1 EA CAST USF R&C 170-XB~FDOT~STORM

FDOT INDEX #200/201 STORM MANHOLE # S-106

FDOT 434986-1-52-01

10960723S-106.idw

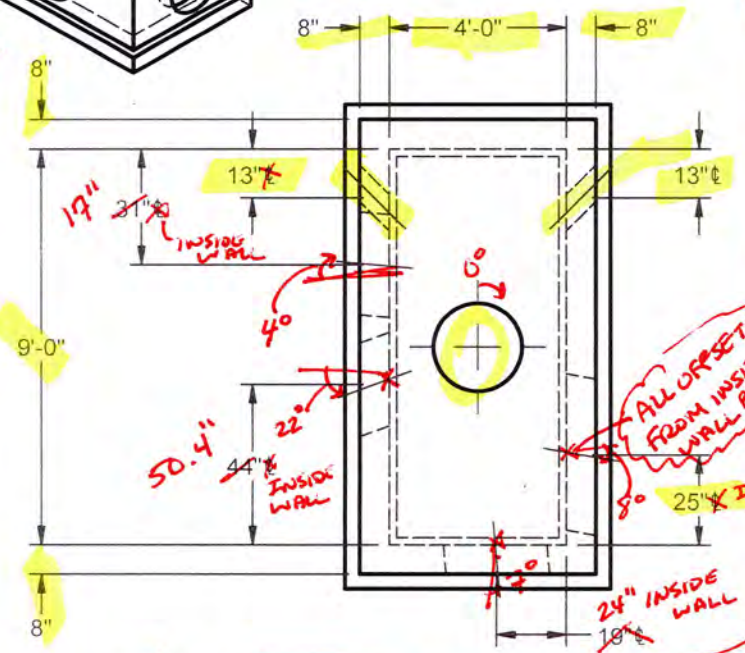
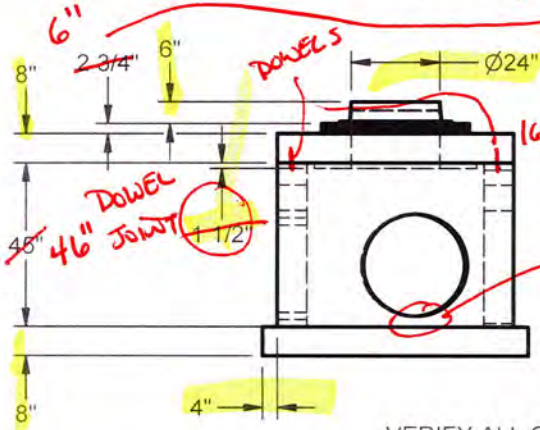
DUE TO NOT HAVING 6" OF CONCRETE ABOVE THE HOLE OPENINGS IN WALL, FDOT WILL REQUIRE THIS SHOP DRAWING TO BE APPROVED BY THE EOR PRIOR TO MANUFACTURE.

FG =	164.28
TA =	163.78
TTS =	~~163.55~~ 163.28
TPW1 =	~~162.88~~ 162.62
ITB =	~~159.13~~ 158.80
APTB =	~~4.65~~ 4.98

VERIFY ALL OFFSETS

PC #	WEIGHT	PIECE DESCRIPTION	PRODUCT CODE
		PER INDEX 201 SHEET 3 OF 5, INCREASING THE UP ELEVATION TO 6" (HOLE RISE) ALLOWS THE CONCRETE ABOVE THE HOLE OPENING TO BE ZERO, USING DOWEL JOINTS.	
		INCREASE ADJUSTMENT TO STAY OUT OF CONCRETE ROAD TOP OF PIPE WILL BE CLOSE TO ~~BOT~~ BOTTOM OF 8" SLAB (0" BLANKOUT ON TOP OF 30" RCP)	
2	5734 (30" RCP	048L x 108W x 08Wall x 08H, TopSlab	SS08408408S008N
1	15105	048L x 108W x 08Wall x 045H, MonoBaseExt	SS08408408B048X

PC #	DEG/ DIR	PIPE SIZE	PIPE INVERT	HOLE SIZE (INSIDE WALL OFFSET)	BOOT TYPE	HOLE INVERT	HOLE RAISE
1	E	4 PVC	162.00	7H x 18W (C/L 13 Off N Wall)	NONE	161.88	~~33"~~ 37"
1	E 98°	30 RCP	159.80	42 (C/L 25 Off S Wall)	NONE	159.3	~~2"~~ 6"
1	S 193°	18 RCP	159.80	28 (C/L 19 Off E Wall) 24"	NONE	159.38	~~3"~~ 7"
1	W 248°	18 PVC	159.93	24 (C/L 44 Off S Wall) 50"	NONE	159.68	~~6 1/2"~~ 10 1/2"
1	W 274°	18 RCP	159.80	28 (C/L 31 Off N Wall) 17"	NONE	159.38	~~3"~~ 7"
1	W	4 PVC	162.00	7H x 18W (C/L 13 Off N Wall)	NONE	161.88	~~33"~~ 37"

INSURE NOT CONFLICT W/ 18" RCP
